RE: 2125064 - GIEBEIG - FEAGLE RES.

This package includes 1 individual, Truss Design Drawings and 0 Additional Drawings.
With my seal affixed to this sheet, I hereby certify that I am the Truss Design Engineer and this index sheet conforms to 61G15-31.003, section 5 of the Florida Board of Professional Engineers Rules.

REPAIR(S) REQUIRED

| Job | Truss | Truss Type | Qty | Ply | GIEBEIG - FEAGLE RES. | T19136700 |

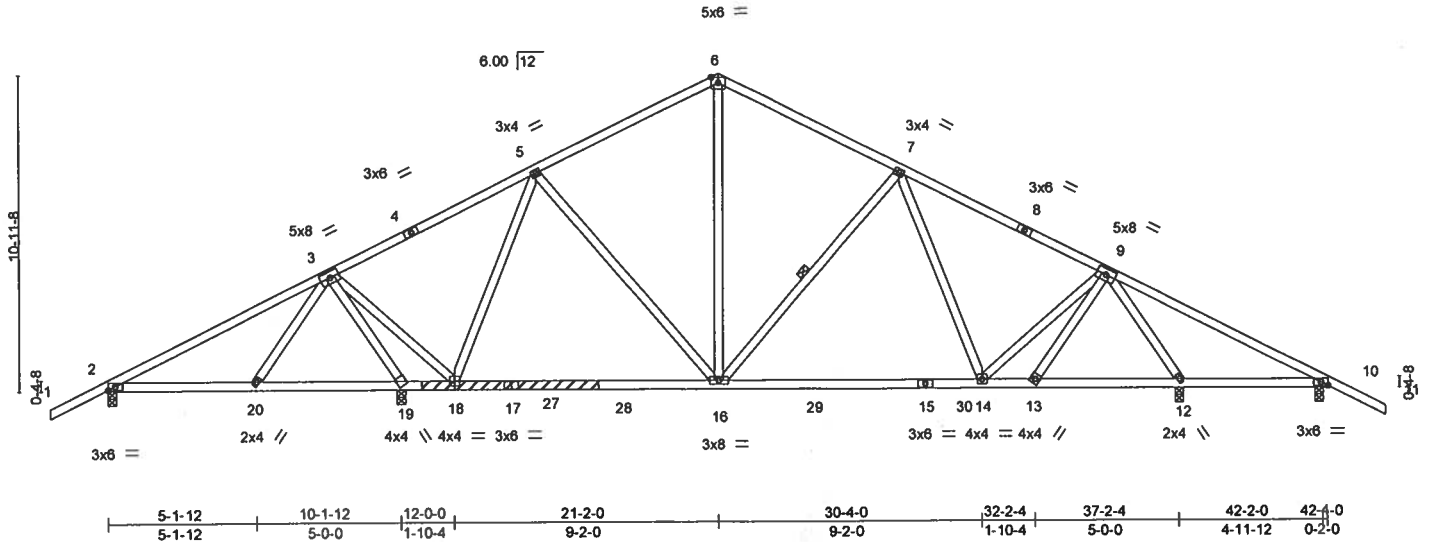
- 1) Repair Condition: Missing or damaged plate(s) on both side(s) of truss at joint(s) 17.
- 2) Apply 72" long 2x4 SP No.2 scab to front side(s) of truss centered on damage at joint 17 with 2 row(s) of 10d (0.131"x3") nails spaced 2" o.c. from front face. Minimum 0-3-0 end distance.
